Subject: Application for Amendment to Facility Operating License  
Control Room Emergency Air Treatment System (CREATS) Actuation  
Instrumentation Change (LCO 3.3.6)  
Rochester Gas and Electric Corporation  
R.E. Ginna Nuclear Power Plant  
Docket No. 50-244

**LICENSE AMENDMENT REQUEST**  
**CONTROL ROOM EMERGENCY AIR TREATMENT SYSTEM (CREATS)**  
**ACTUATION INSTRUMENTATION CHANGE**

**Simplified Diagrams of the Existing and Proposed System Design**

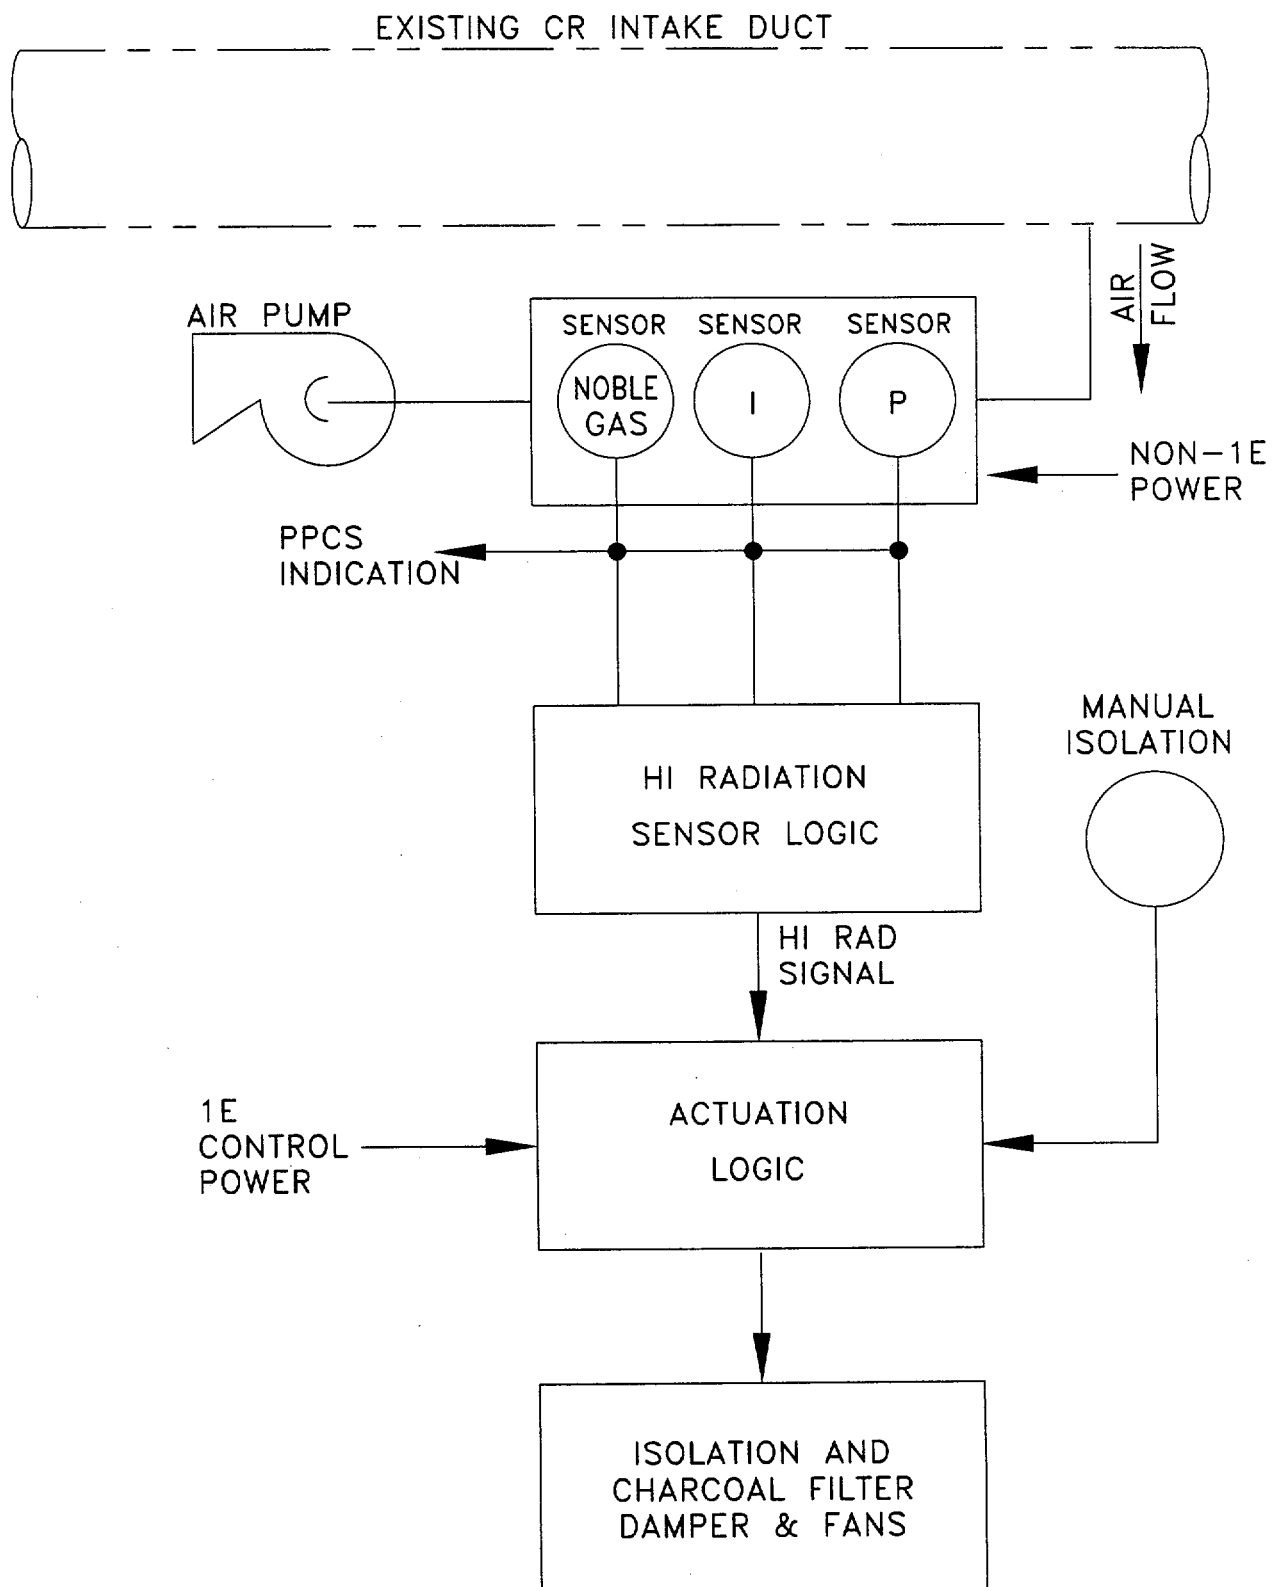
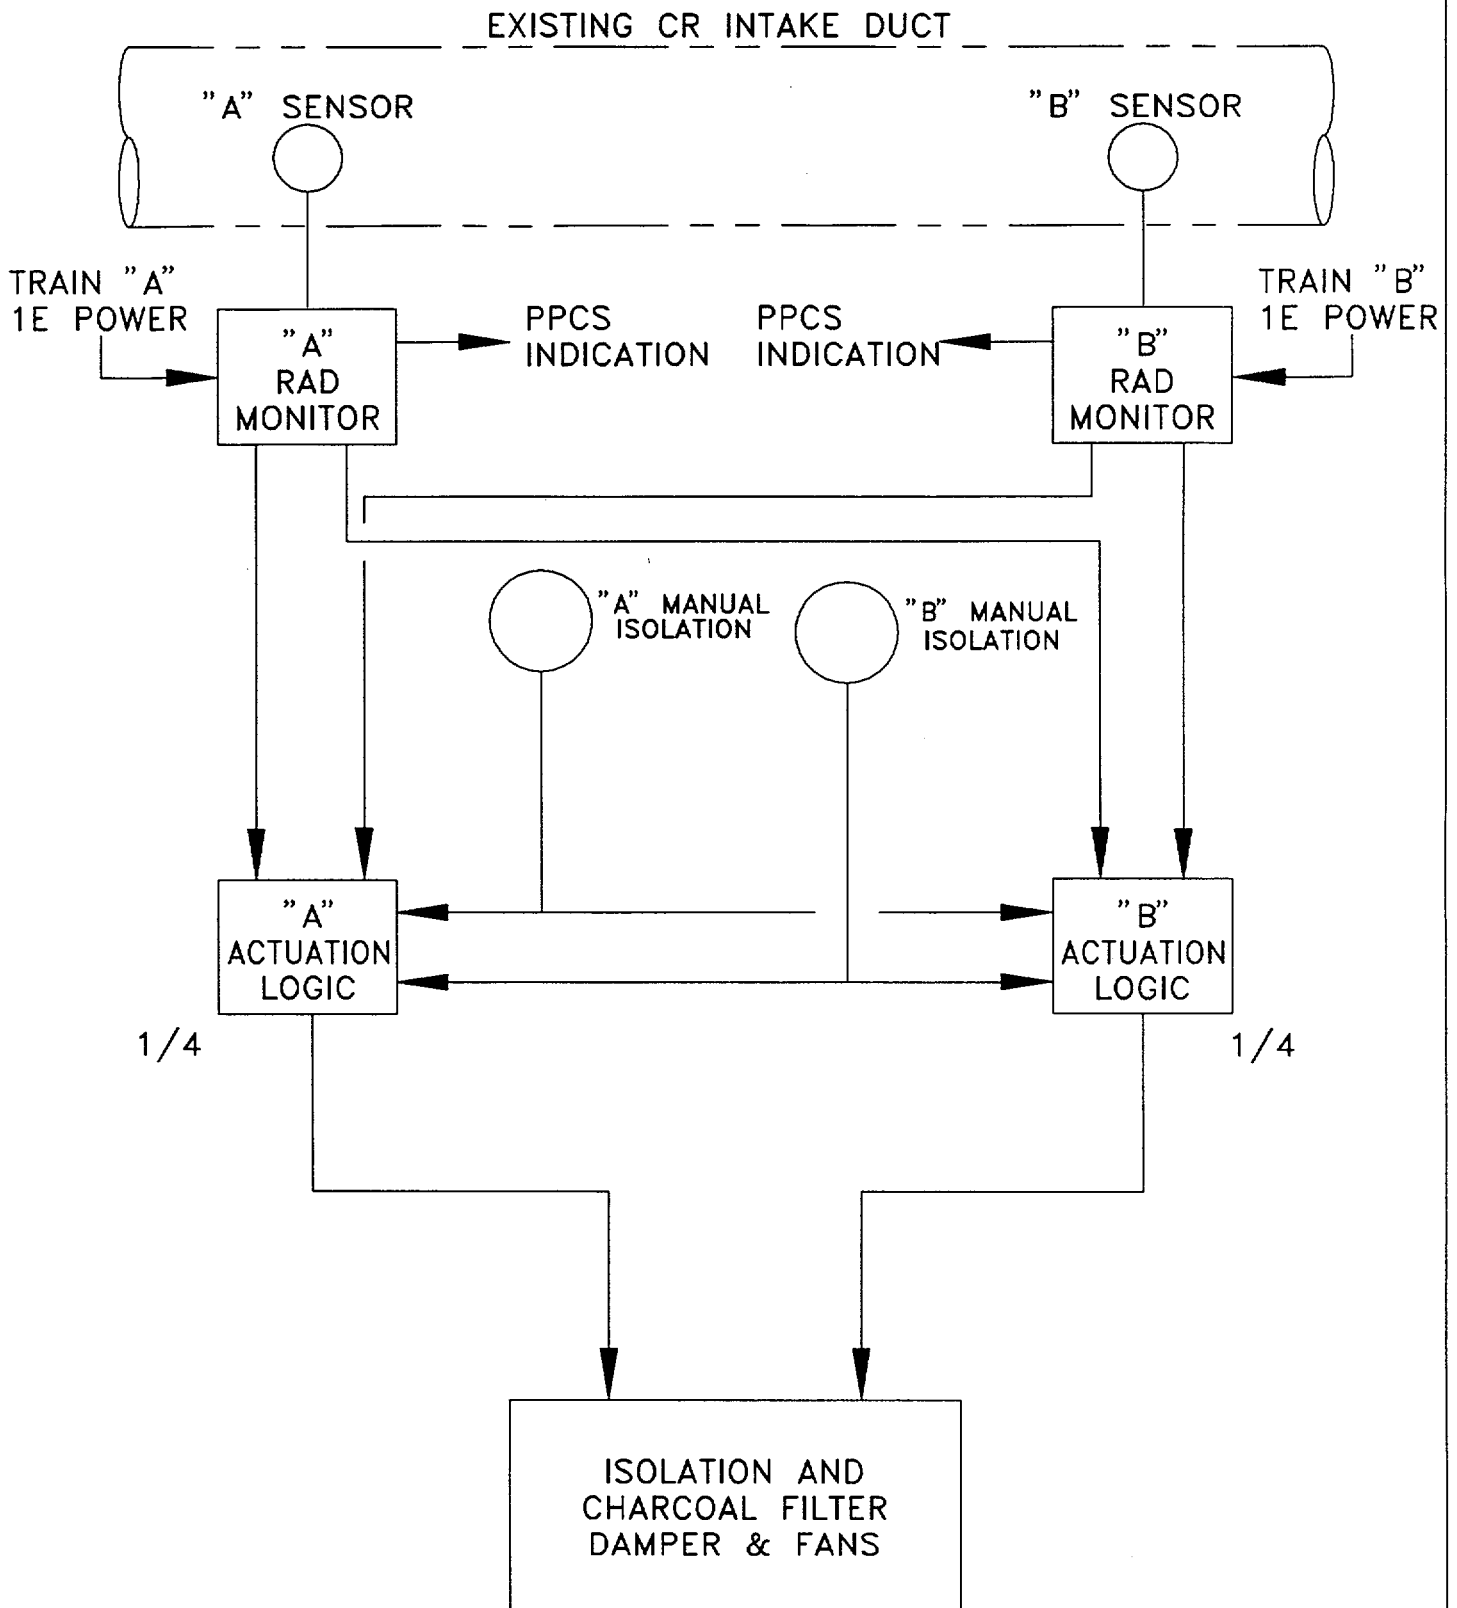
The concerns discussed in Section B.1 have ultimately led to a determination that a system replacement is required to ensure adequate reliability. It is proposed that the existing monitoring system be replaced with a pair of GM tube plenum probes which will measure the radiation within the 42-inch control room ventilation system air intake. The new GM tube plenum probes will be powered from separate safety related sources and be configured into two redundant actuation logic trains, including manual initiation. These detectors will provide a fast and dependable monitoring system. This style of monitor does not depend on a sample pump or any moving parts to accomplish its monitoring function, providing increased system reliability. Attachment VI contains simplified diagrams of the existing and proposed system design.

- L.2 Table 3.3.6-1 is revised to remove reference to the Iodine, Noble Gas, and Particulate Control Room Radiation Intake Monitors and to add reference to the two new GM tube intake monitors. This change is considered to be less restrictive in that the current system utilizes three channels from diverse instrumentation that are treated as three, one-out-of-one functions to initiate actuation of the CREATS filtration train. The new system will utilize a one-out-of-two logic from redundant instrumentation.
